Lower Pearl River Basin Task Force

SUBJECT: Rankin-Hinds Pearl River Flood & Drainage Control District - One Lake Proposal
Integrated Draft Feasibility & Environmental Impact Statement (DFEIS)

Review of the Integrated Draft Feasibility Study and the Environmental Impact Statement (DFEIS) for the Pearl River Basin Federal Flood Risk Management Project (One Lake Project) proposed by the Rankin-Hinds Pearl River Flood & Drainage Control District (the District) in the State of Mississippi for any potential impacts on the Lower Pearl River clearly falls within the subject matter of the task force.

Figure 1. Pearl River Basin Locations of Concern

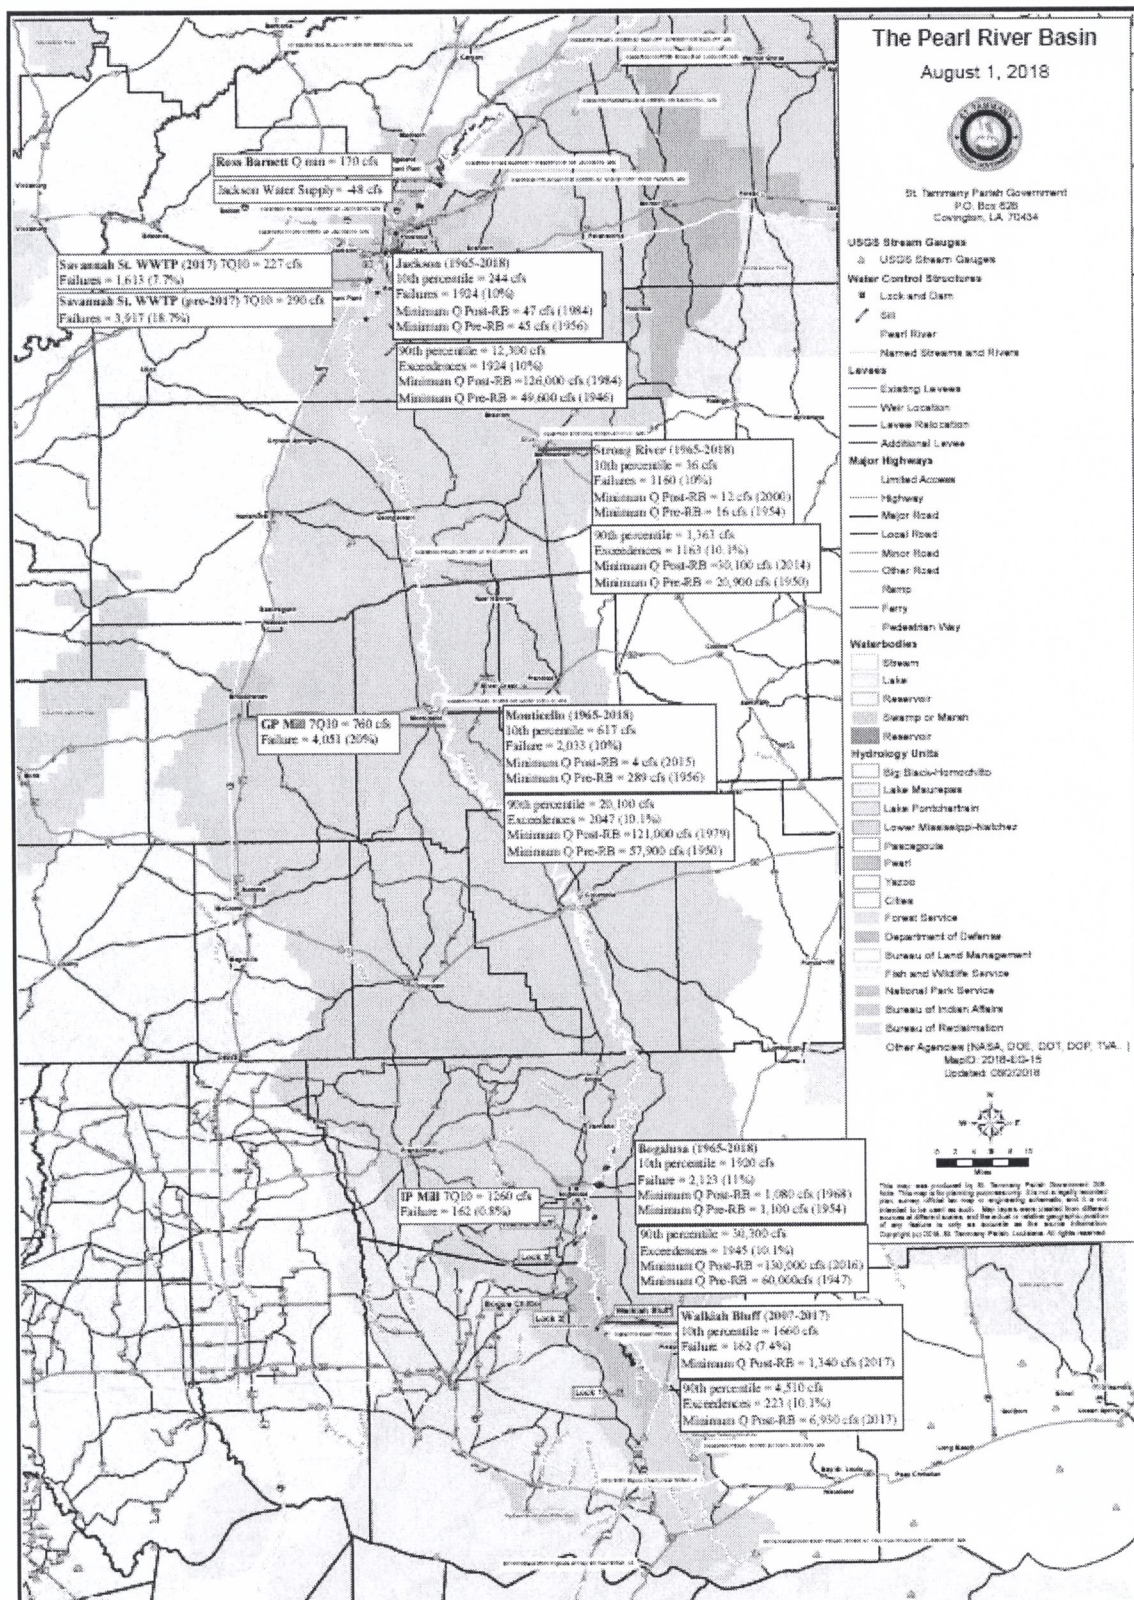
The period of record is also critical to any pre- vs post- RB comparison. St. Tammany considers the correct period-of-record for comparisons to be pre-Ross Barnett (1938-1960) and post-Ross Barnett (1965-present). Figure 1 is a map of the Pearl River Basin indicating areas of concern and providing analyses at these locations.

The EIS authors stated in a public meeting that Richland Creek discharges into the Pearl River between the USGS gage 02486000 Pearl River at Jackson, MS and the Savannah St. WW TP discharge, contributing to the stream baseflow (Figure 1) that would augment the facility's permit requirements.

Figure 2. Pearl River Reach near Proposed Alt. C Impoundment with Flow Characteristics

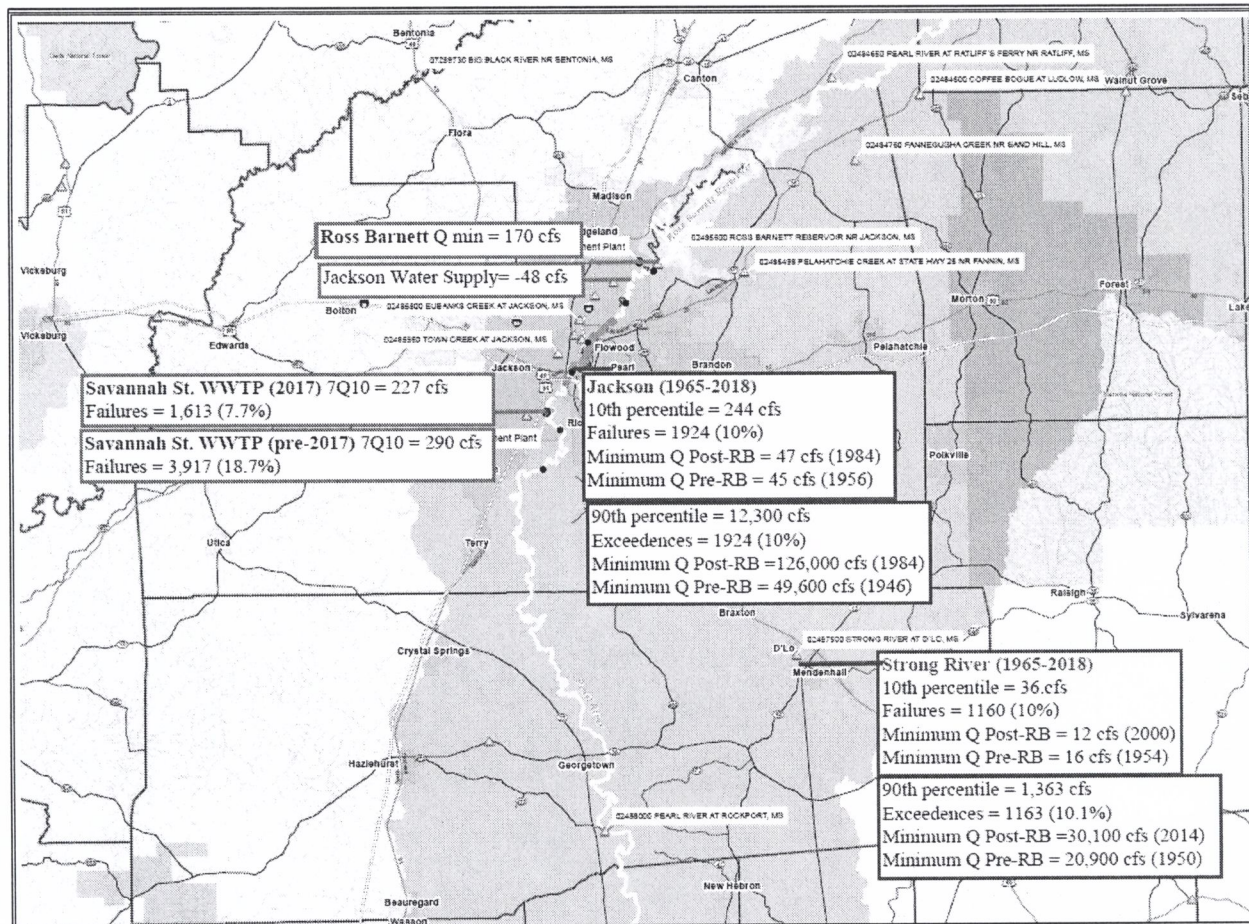
Construction of the Ross Barnett Reservoir (RB) began in 1960 and was completed in 1963. The 33,000 surface acre lake reached “full-pool” capacity in 1965¹. Following construction of the Ross Barnett Reservoir near Jackson, MS, Minimum Mean Daily Discharges have remained approximately the same, from 45 cfs (10/5/1956) to 47 cfs (6/14/1984) for pre-RB versus post-RB, respectively (Figure 2).

Figure 3. Mean Daily Discharge for USGS 02486000 (Pearl River at Jackson, MS) for the period of record

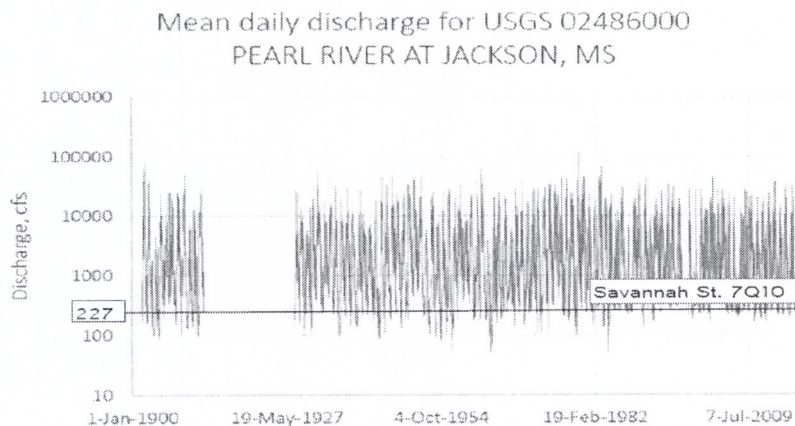
A 7Q10 of 227 cfs is the minimum stream baseflow measured on the USGS gage at Jackson required by MSDEQ for the most recent permit renewal (2017) for the 46 MGD City of Jackson Savannah St. WWTP discharge. Post-RB, there were 1,613 failures (7.7%) to meet this minimum flowrate (Figure 1). Mean Daily Discharge on the gage at Jackson show many measurements that are lower than the required 227 cfs for City of Jackson, Savannah St. Wastewater Treatment Plant (WWTP), as seen on the hydrograph in Figure 3.

The previous NPDES permit for the Savannah St. WWTP set the stream baseflow at 290 cfs for which there were 3,917 failures (18.7%). It seems counter intuitive that the permit should have been issued with a lower stream baseflow, with the River's history of not attaining adequate flow. A TMDL for Nutrients² was implemented by EPA and MSDEQ in 2015 for the Pearl River from Ross Barnett to the Strong River. It seems plausible that inadequate stream baseflow at the Jackson gage during summer-critical conditions may be contributing to the lack of assimilative capacity at this location in the River incurring the TMDL.

Figure 4. Pearl River Reach near Monticello, MS with Flow Characteristics

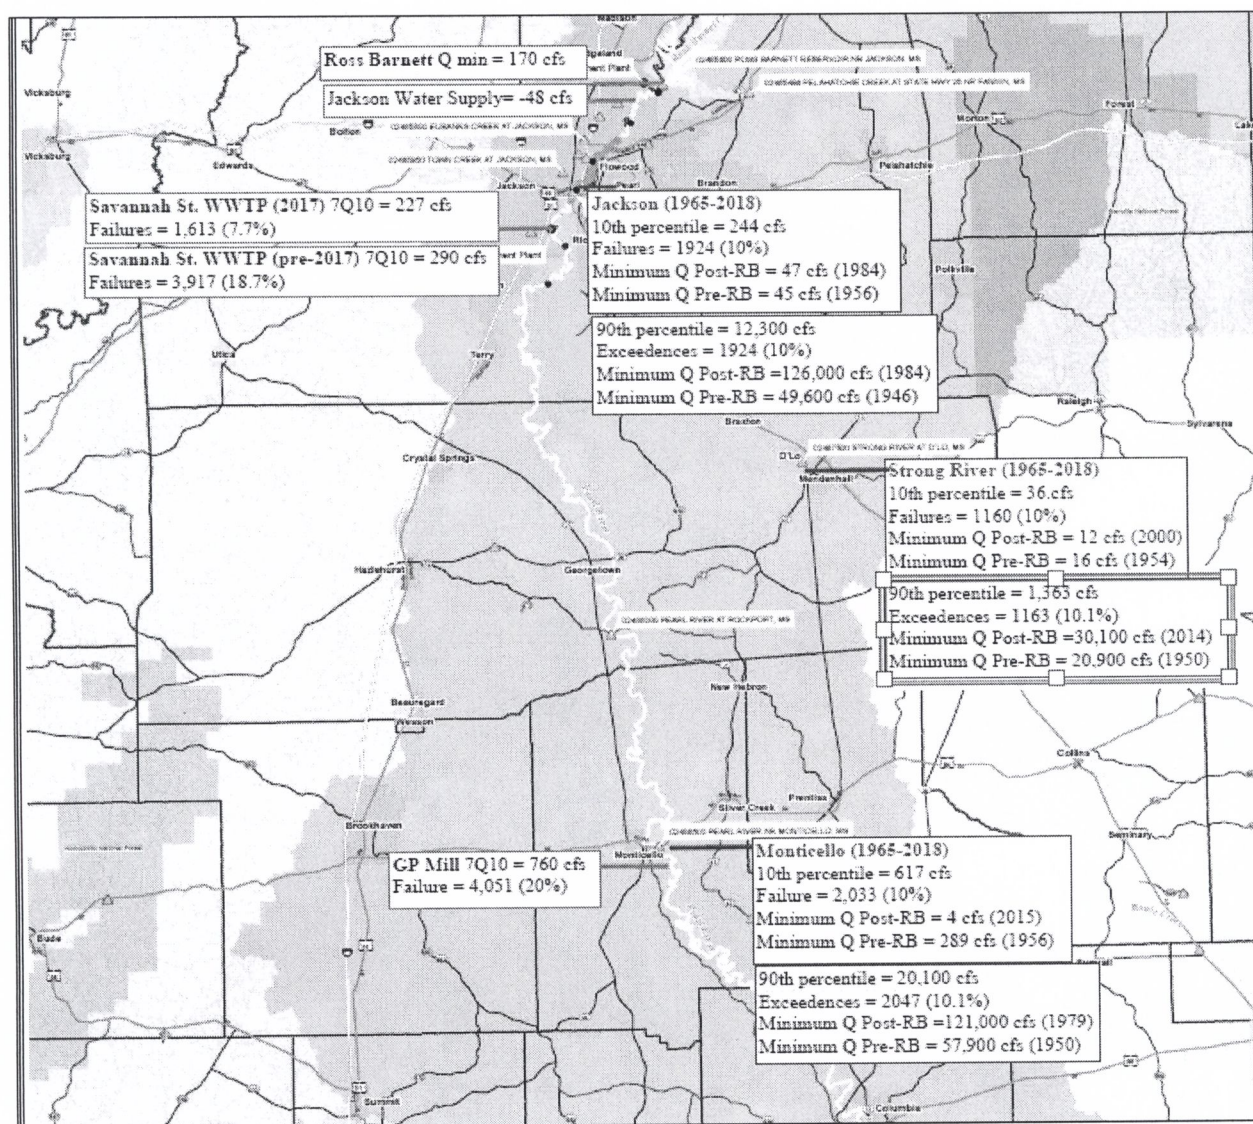
Monticello, MS is the location of a large NPDES discharger, Georgia Pacific (GP) Paper Mill (Figure 4). The 10th percentile flow post-RB is 512 cfs measured at the gage USGS 02488500 Pearl River at Monticello, MS, of which there were 854 measurements that failed to meet the 10th percentile (11%). The historic minimum flow at that location is 4.02 cfs. Residents along the River relay stories that the water was so low at that time that one could walk across to the other bank.

The 7Q10 for the 26.04 MGD (40.3 cfs) GP facility requires a stream baseflow of 760 cfs. There were 4,051 Daily Mean Discharge measurements (20%) that failed to meet that minimum. The Strong River, upstream of the Monticello gage, augments flow at this location (Figure 1); however, the post-RB 10th percentile for the Strong is 36 cfs measured at USGS 02487500 Strong River at D'Lo, MS. 1,160 Daily Mean Discharges failed to meet the 10th percentile (10%). The historic minimum was 12 cfs (8/31/2000).

Figure 5. Pearl River Reach near Bogalusa, LA with Flow Characteristics

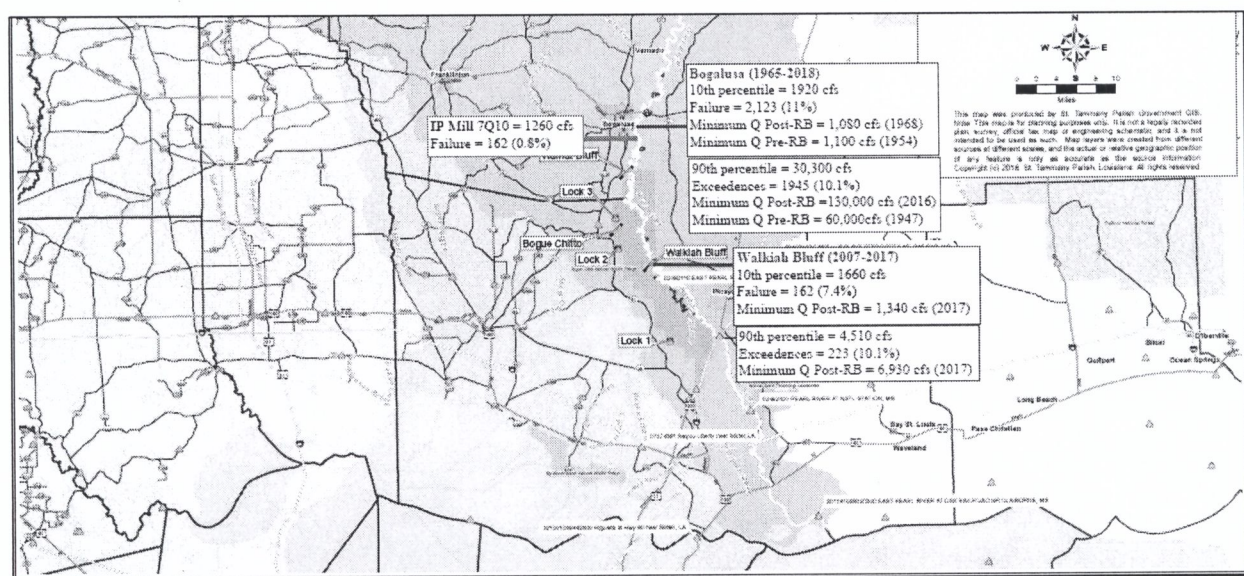
Bogalusa, LA is the location of a large NPDES discharger, International Paper (IP) Mill (Figure 5). The 10th percentile flow post-RB is 1,920 cfs, of which there were 2123 Daily Mean Discharges that failed to meet the 10th percentile (11%). The historic post-RB minimum flow at that location is 1,080 cfs. The 7Q10 for the 16 MGD (24.8 cfs) IP facility requires a stream baseflow of 1,260 cfs. There were 162 post-RB Daily Average Discharge measurements (0.8%) that failed to meet that minimum. While the minimum stream baseflow for this facility was well determined for the permit, there is little margin of safety in the stream baseflow, potentially incurring in-stream water quality violations during summer-critical conditions.

- There is a need for additional stream baseflow augmentation at this location in the Pearl River.

This site is of particular interest to oyster culture in coastal MS and LA (Figure 5). Adequate freshwater during summer critical conditions is necessary to mitigate the effects of saltwater intrusion and survivability of oysters in Lake Pontchartrain and the Mississippi Sound. Walkiah Bluff was constructed by the USACE to divert freshwater to the East Peal River during low-flow conditions. The 10th percentile Daily Mean Discharge measured at this gage is 1,660 cfs, of which 162 measurements <10th percentile (2007-2018). The historic minimum flow was 1,340 cfs (10/15/2007). A significant amount of debris is reportedly blocking the structure's weir lessening the amount of fresh water being diverted.

Figure 6. Minimum Mean Daily Flows by Month minus proposed evaporative losses

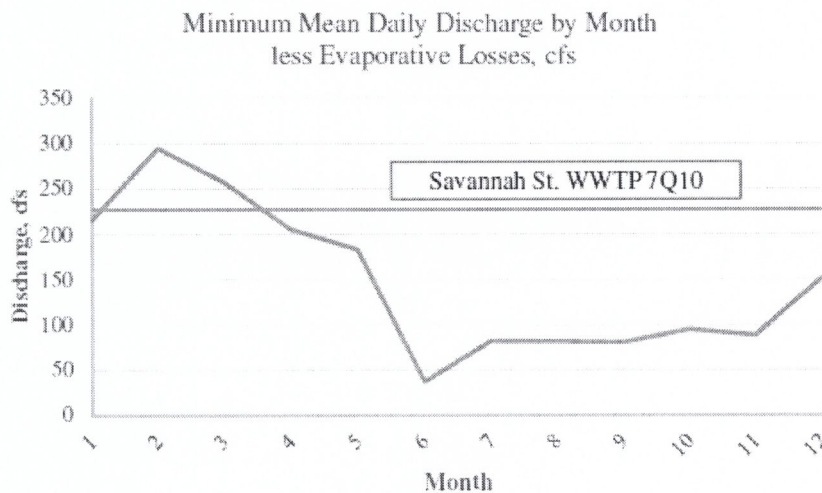
- Evaporative losses subtracted from either the Minimum Daily Mean Discharges by Month (Figure 6) or the 10th percentile of Mean Daily Discharges (Table 5) indicate the already-impacted Pearl River will be further compromised.

Figure 9. Predicted DO vs Observed DO at Sample Location downstream of the Ross Barnett gates

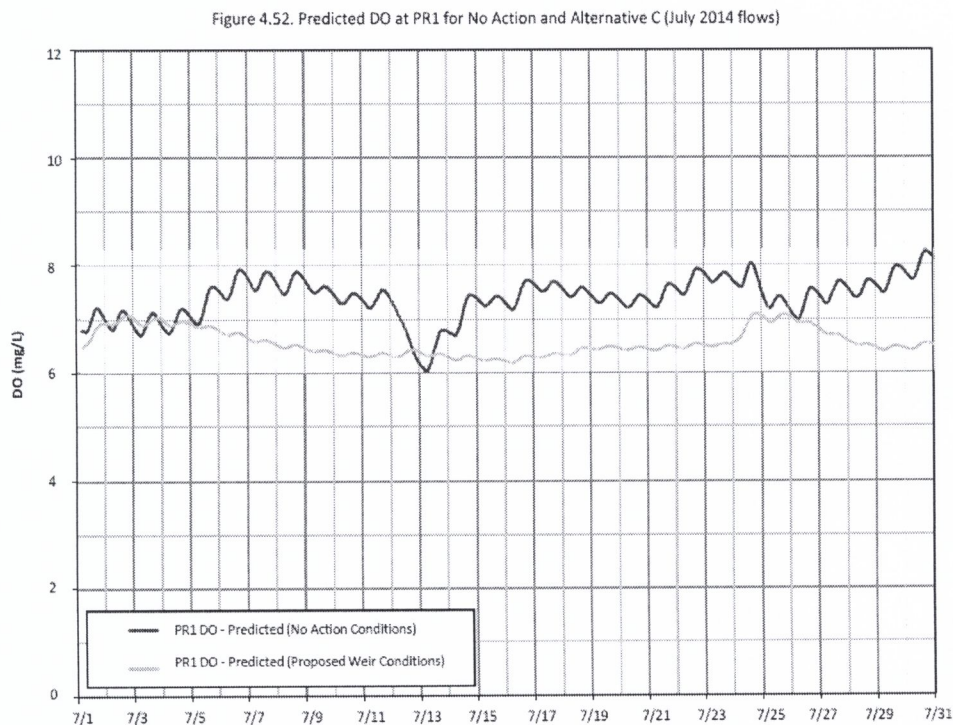
Using data from the July 2014 sampling event, the EIS team developed a model to predict the impact of the proposed impoundment. Figure 9 (EIS Appendix D, Water Quality, pg.119) presents model output of dissolved oxygen (DO) for two scenarios: 1) “No Action” (current conditions) and 2) Alternative C scenario. In the “No action” scenario, DO is significantly higher than the Alt. C scenario; however, EIS reviewers are assured that the DO in the Alt. C scenario will remain above the CWA criteria of 5.0 mg/L. Reviewers are asked to believe that the flow rates, pollutant concentrations, temperatures and decay coefficients used in the model are also correct. Assuming the 10th percentile flow rates were to be used, it is doubtful that the DO would maintain CWA DO minimums.

Further, DO appears to FAIL EPA anti-degradation criteria for dissolved oxygen (< 0.2 mg/L) with Alt. C impoundment. LDEQ’s water quality standards define degradation as “a lowering of water quality, as demonstrated by data analysis, water quality models, or other scientifically defensible method.” So, a lowering of the dissolved oxygen content, as predicted by a model, is considered degradation. Per LAC 33: IX, Chapter 15 (Water Quality Certification Procedures), LDEQ has the responsibility to certify that federal permits or licenses will not violate water quality standards, so the application of the antidegradation policy is not limited to industrial discharges.

- In reviewing the discharge from the proposed Alt. C impoundment, MSDEQ and USACE are encouraged to require compliance with the CWA anti-degradation standard upon submittal of the final EIS and again at the USACE permit application.

Figure 10. Locations of Coastal Restoration Projects and CRMS sites in the Pearl River vicinity

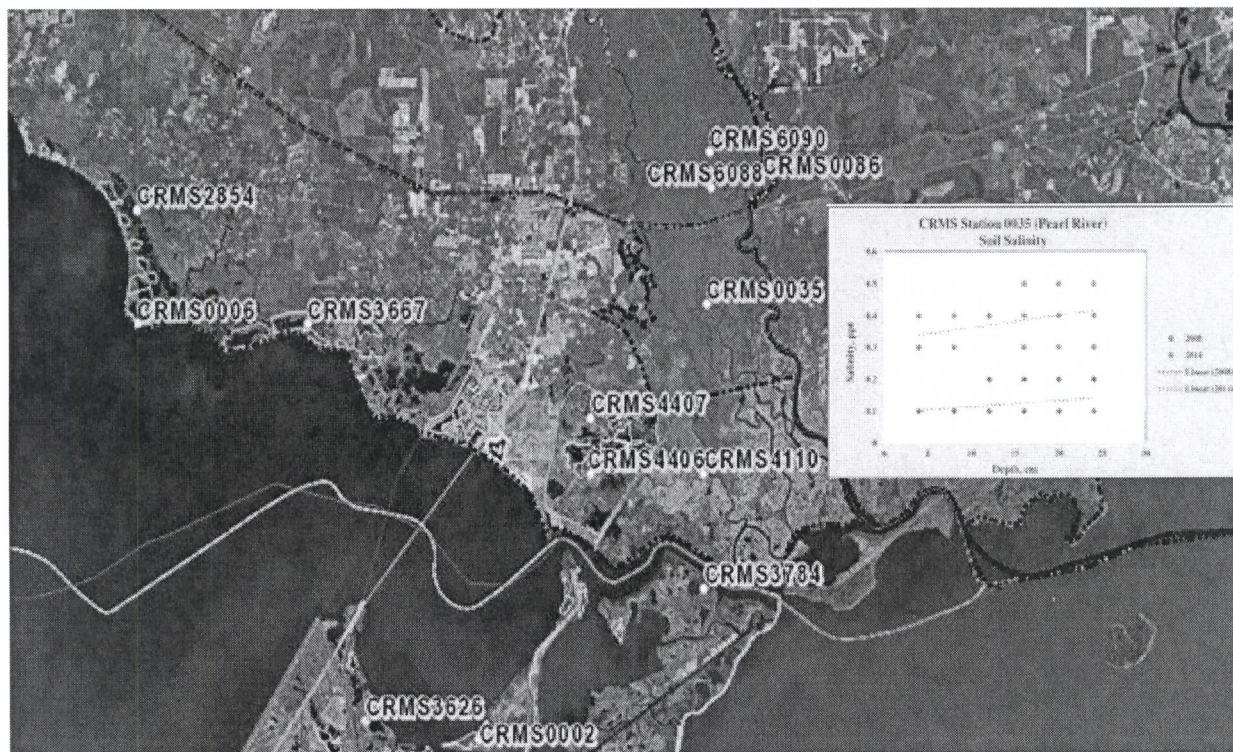
Since 2006, the Louisiana Coastal Protection and Restoration Authority (CPRA) and the US Geological Survey (USGS) have developed and maintained a Coastwide Reference Monitoring System (CRMS) for wetland restoration efforts. There are three CRMS sites in the vicinity of coastal Pearl River and a number of coastal restoration projects that are in the construction or engineering/development phase (Figure 10). These projects are vital to the restoration and resiliency of the Louisiana coastline and provide surge protection to inland communities.

The CRMS site houses monitoring datasets of hydrogeomorphological parameters that characterize coastal habitats in Louisiana. Some of the parameters that are monitored include water level, soil porewater salinity, percent organic content and surface elevation/accretion. The CRMS site link is: <http://www.lacoast.gov/crms2/Home.aspx>. All CRMS indicate increased saline concentration in porewater, perhaps attributable to less fresh water flowing down the Pearl River in low flow months.

- St. Tammany Parish recommends that monitoring at the CRMS sites continue, particularly to monitor for salt water intrusion.
